**Technical Review of Entrained  
Design Report**

**December 14, 1979**

Pilot Plant," dated August 1979, prepared by Science Applications, Inc. (SAI).

FIGURE 4-1 - Basis for char cooler heat transfer calculations.

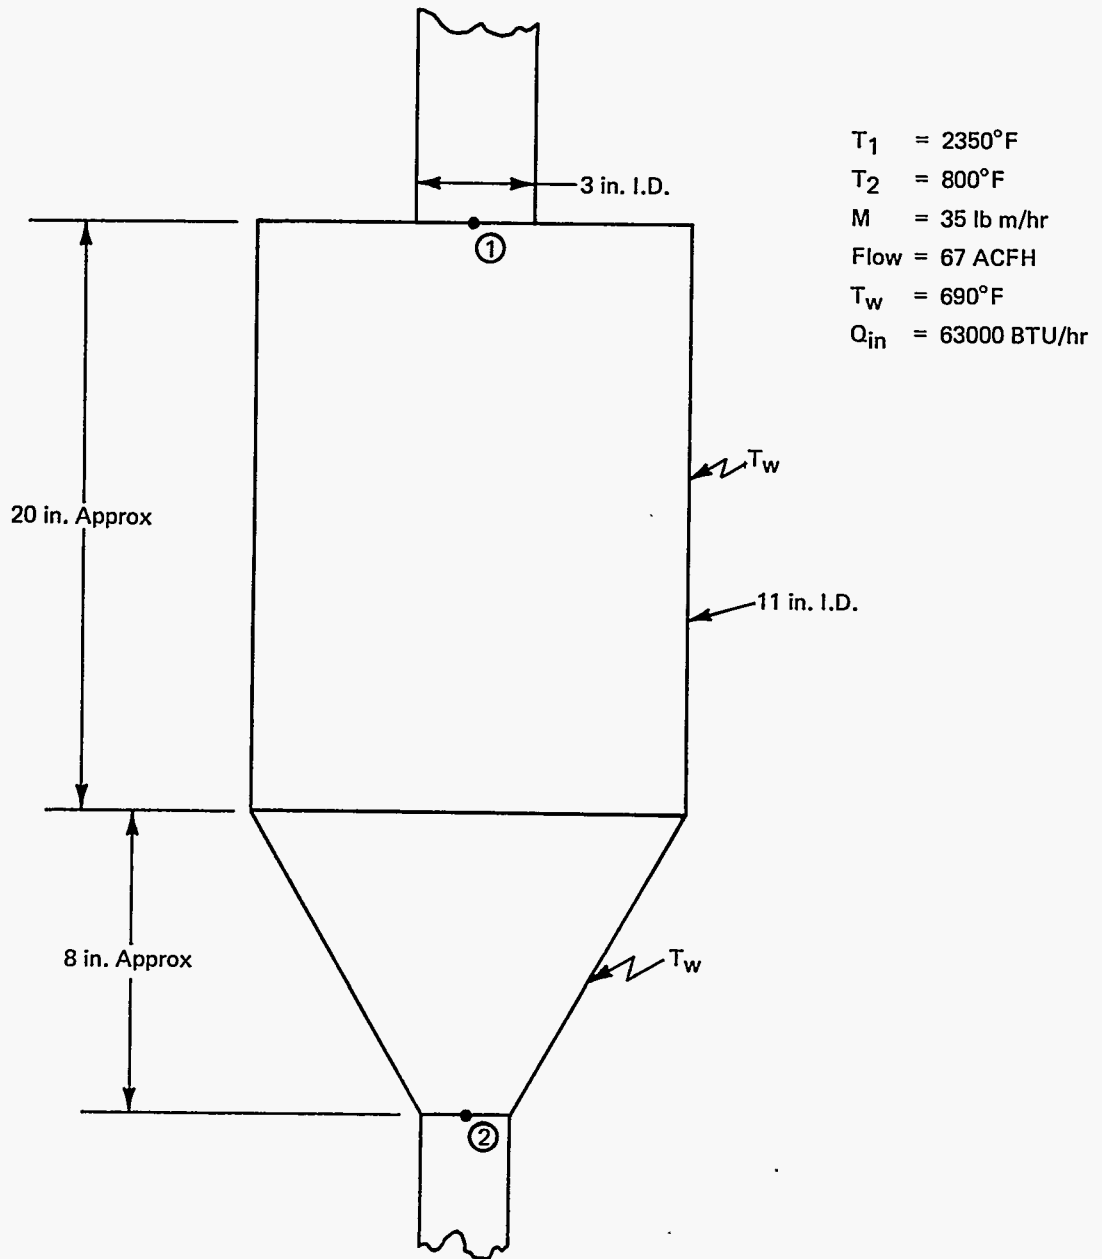
There is some concern regarding the ability of the char cooler to cool the char and gases adequately for worst condition cases. Thus, the following preliminary analysis was considered:

Note Figure 4-1 for the cooler conditions and sizes.

Compared to a maximum amount of energy to be removed of 63,000 BTU/hr, the heat exchanger calculations indicate an oversizing by a factor of approximately 2. With the aforementioned assumptions, particularly the constant wall temperature, this sizing would be appropriate. Finally, these calculations are preliminary and further analysis is advisable.

FIGURE 6-1 - Suggested facility and exclusion layout.

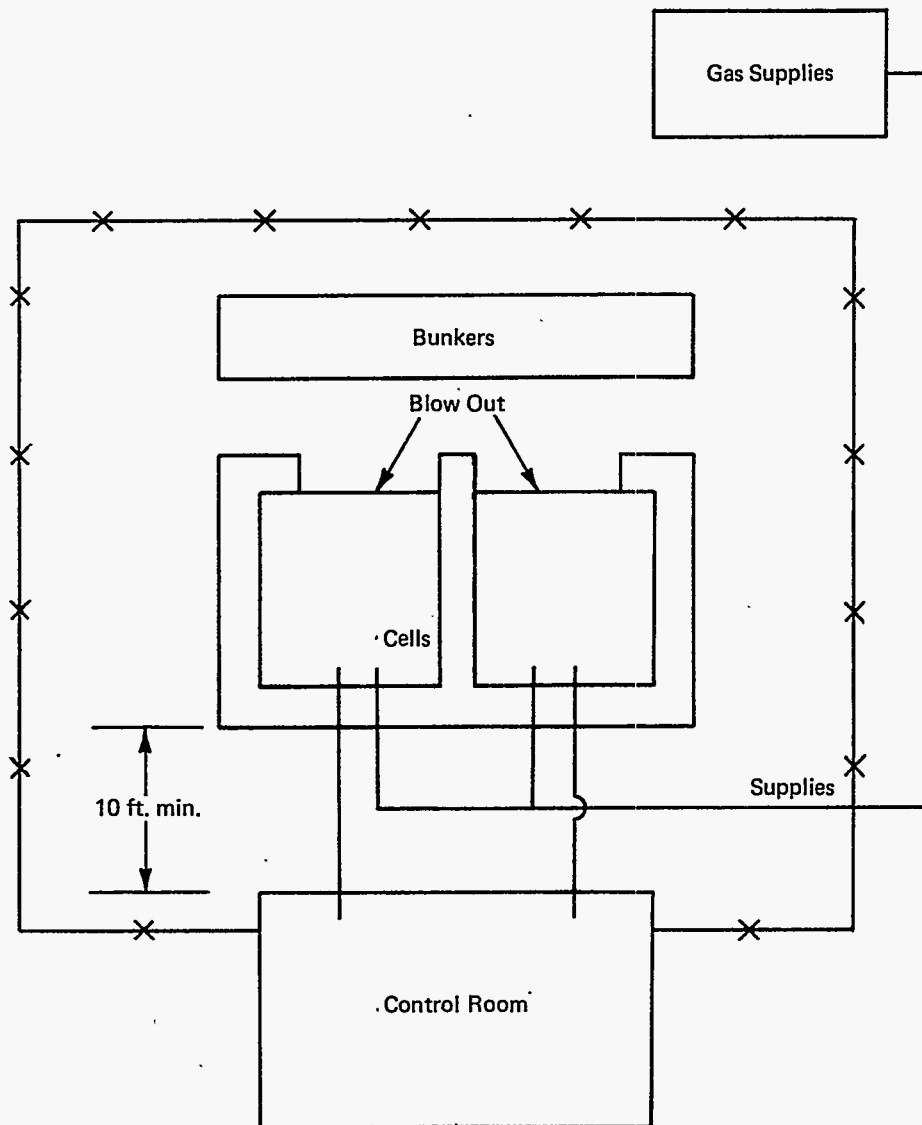
impinge on each other. This will probably exclude all gas storage, etc. from the proposed fenced area. Also, supply lines should not be endangered by the cell relief mechanism, see Figure 6-1.

To enable the monitoring system to be used to detect leaks, the cell ventilation should be set at the minimum level required to prevent heat buildup. To

further reduce required ventilation, all heat generating equipment that is not an explosion hazard can be placed outside the cell. This will also reduce exposure of maintenance personnel to hazards presented by the process equipment in the cell.
